ACCESSION NBR:7903120359 DOC.DATE: 79/03/02 NOTARIZED: NO DOCKET #
 FACIL:50-220 NINE MILE POINT NUCLEAR STATIONS, NIAGARA MOHAWK POWE 05000220
 AUTH.NAME AUTHOR AFFILIATION
 DISE,D.P. NIAGARA MOHAWK POWER CORP.
 RECIP.NAME RECIPIENT AFFILIATION
 IPPOLITO,T.A. OPERATING REACTORS BRANCH 3

SUBJECT: DESCRIBES PLANNED MODS TO TORUS WHICH ARE DESIGNED TO
 MITIGATE LOADS DEFINED BY MARK I CONTAINMENT PROGRAM.

NINE MILE POINT UNIT 1

TORUS AND ASSOCIATED
MODIFICATIONS

FIGURE 1

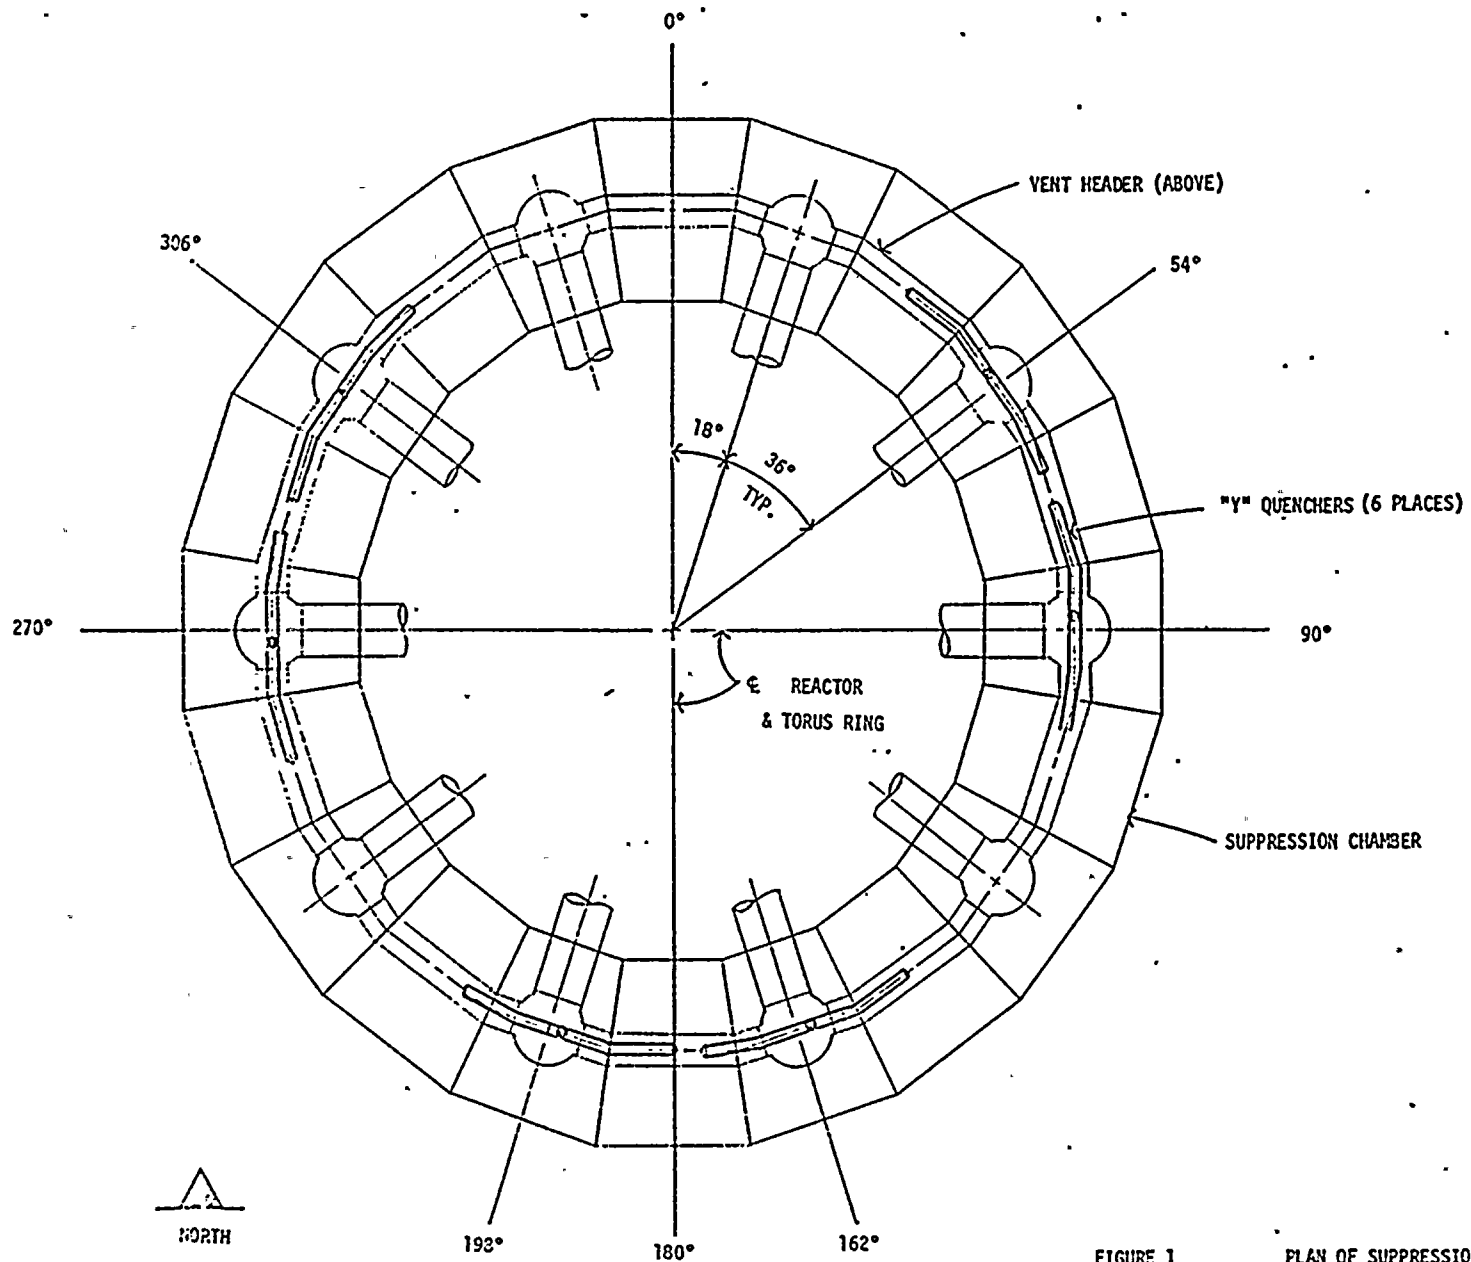
1. Y-Quenchers will be installed to replace the present ramsheads. These will reduce the loads associated with relief valve discharge. As a result of the downward thrust associated with the relief valve blowdown, additional reinforcing will be made at the sphere penetration where the relief valve line enters the torus. Once installation of the quenchers has been completed, a test will be performed prior to startup to quantify its effectiveness. Figures 1 and 2 show these modifications.

FIGURE 2

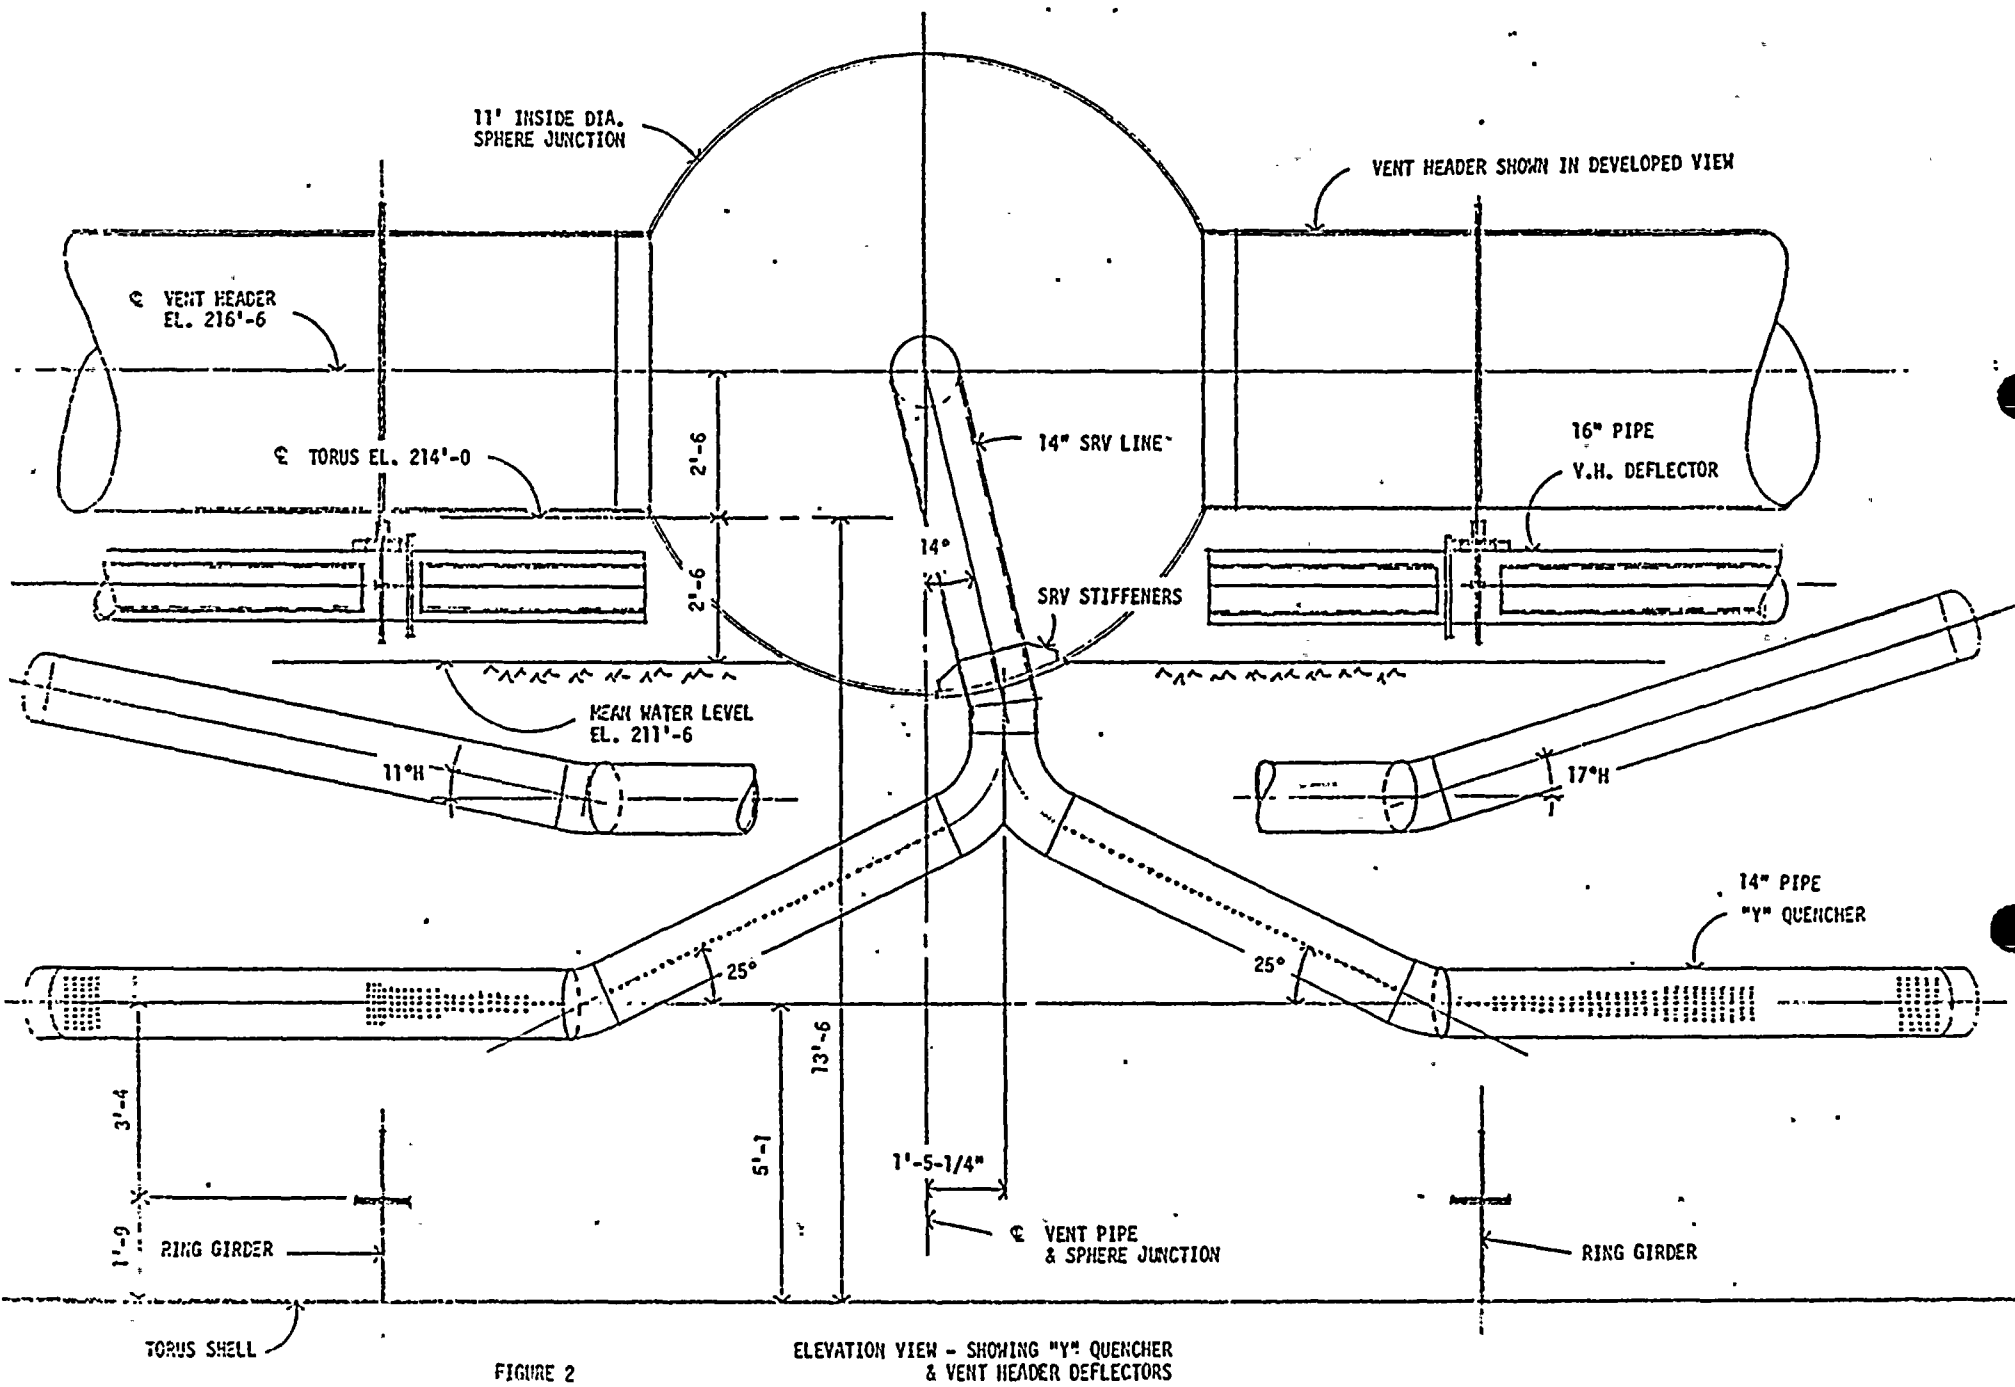
2. A vent header deflector and supports will be installed as shown in Figures 2 through 5. These devices reduce pool swell loads on the ring header.
3. Downcomer Tie Straps - The downcomer tie straps will be removed and replaced as shown on Figure 6. The new tie straps will provide more load carrying capability. The removal of the old straps will facilitate installation of the vent header deflectors.
